Subject: Durham-Orange Light Rail Electrification Impact Study Document  
Overview

The objective of this Letter Report is to: 1) Review the LTK EMI modeling and predicted EMF magnetic and electric fields anticipated from the proposed Durham-Orange Light Rail DC traction system, conductors and current flowing from overhead catenary cables; and 2) Provide comments on the LTK emission Zone 3 and predicted magnetic field emissions at various Duke research and medical buildings.

**Initial Assessment: Durham-Orange Light Rail Electrification Impact Study**  
Page 2, 5<sup>th</sup> paragraph:

Diagram #1, Zone 2 OCS Current – Train WB

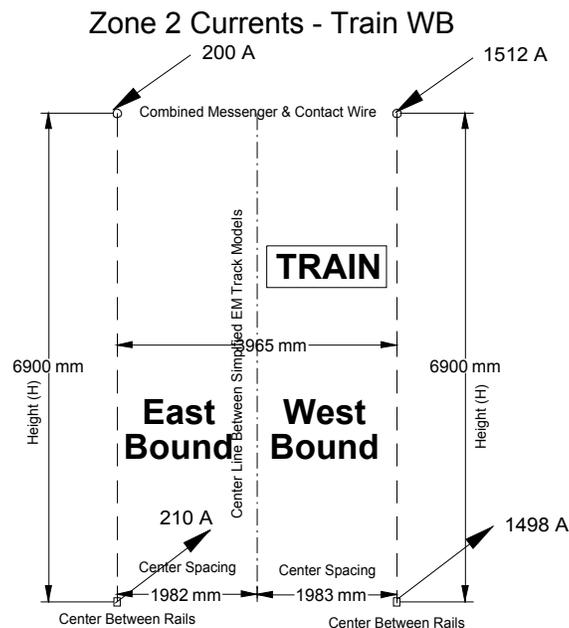
Vitatech generated a simplified quasi-static DC magnetic field simulation model and overlay based upon the worst-case OCS 1512 A current shown in Diagram #1 below:

Figure #1, OCS Durham-Orange Light Rail 1500A Simulation Profile

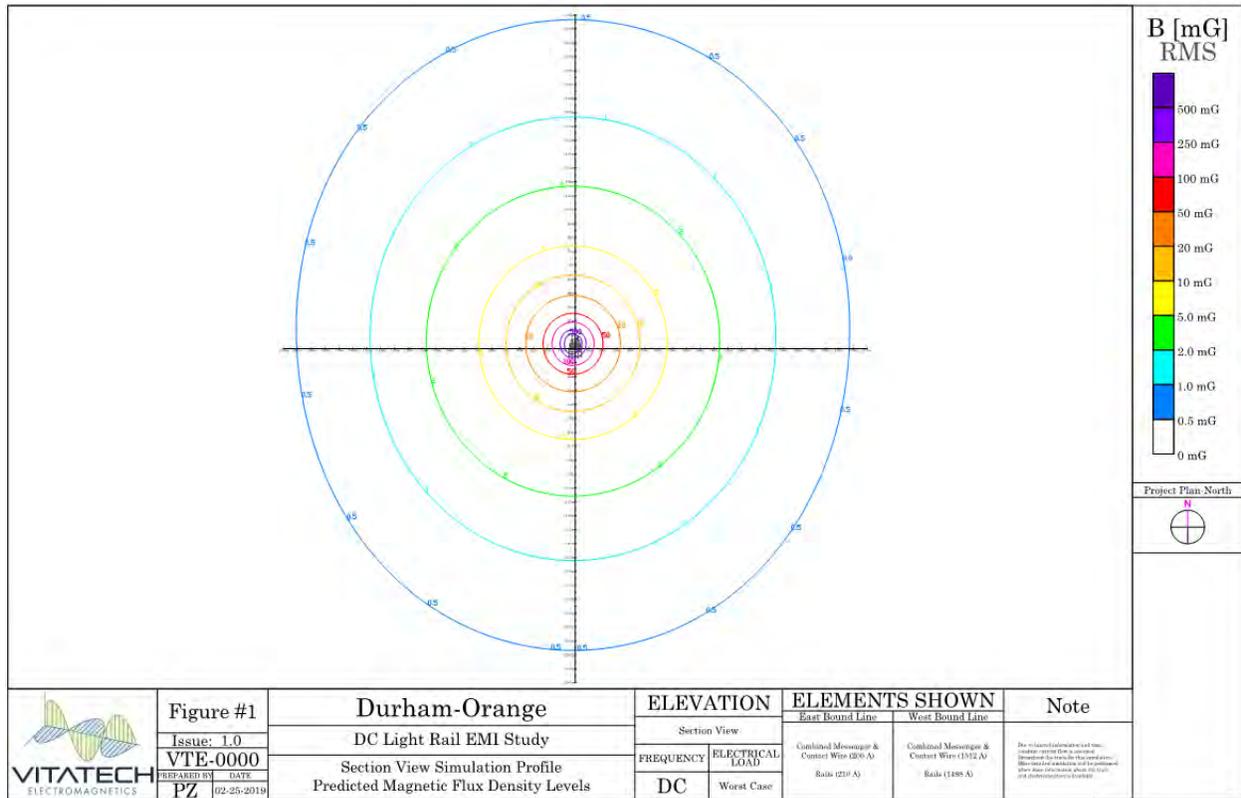
Figure #1 on the next page shows an elevation view of Vitatech's Diagram #1 simulation model at 1500A. The horizontal 0.5 mG RMS isoline is 200m (656 ft.) along the X-axis and the vertical 0.5 mG RMS isoline is 237m (777 ft.) along the Y-axis. This is the worst-case 0.5 mG RMS quasi-static DC extent boundary as the Light Rail cars travel along the alignment. Figure #2, Zone 3, quasi-static DC magnetic field isolines shown on the next page are based upon the 2m elevation (y-axis) slice of Figure #1.

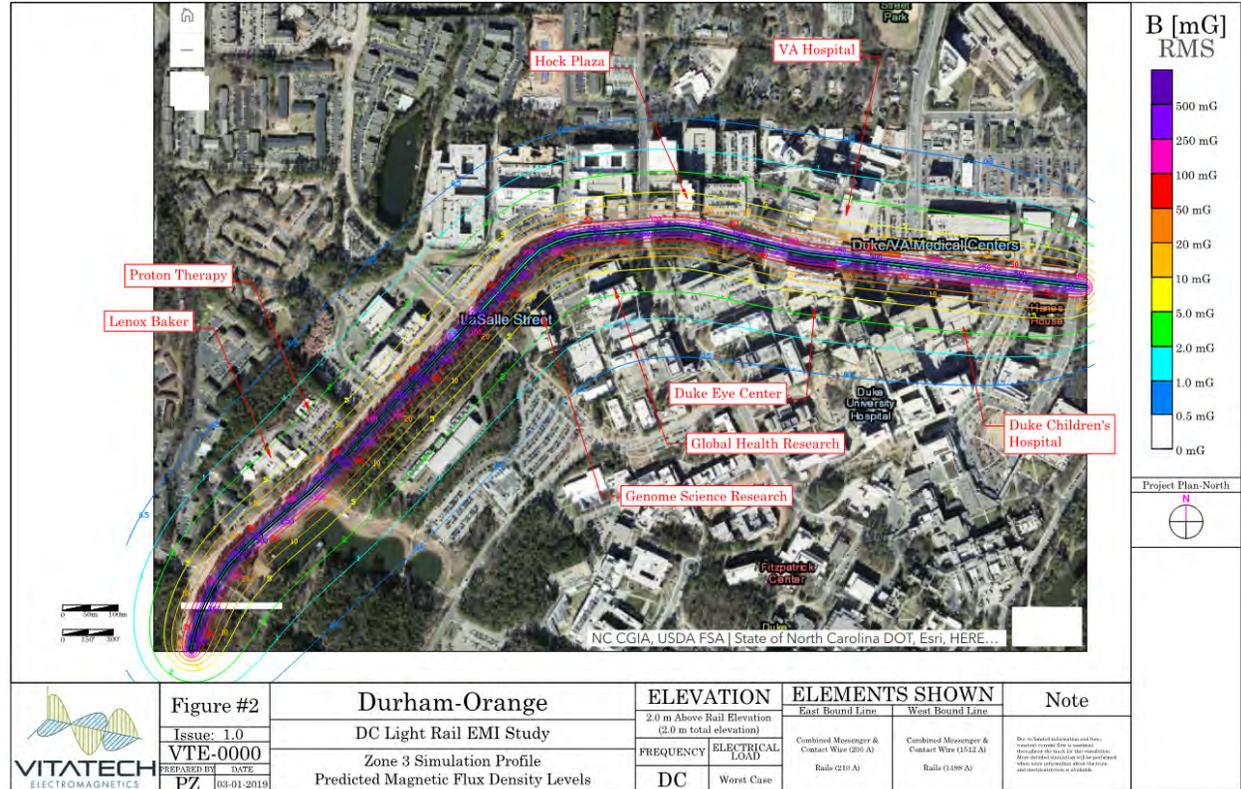
Figure #2 below shows Vitatech’s combined Zone 3a & 3b simulation model at 1500A.

Based upon the Light Rail alignment proximity to the Zone 3a and 3b in the Report, Vitatech is very concerned there will be quasi-static DC EMI compliance issues with many of the electron microscopes and MRIs / NMRs. (see Table #1 tool EMI threshold criteria):

It should be noted that the Vitatech Zone 3 simulation model is similar in magnitude to the Report Zone 3a and 3b models; however, our Figure #2 simulation is easier to read with 1 mG RMS and 0.5 mG RMS quasi-static DC isolines for additional detailed resolution and potential EM tool EMI impact susceptibility assessment.
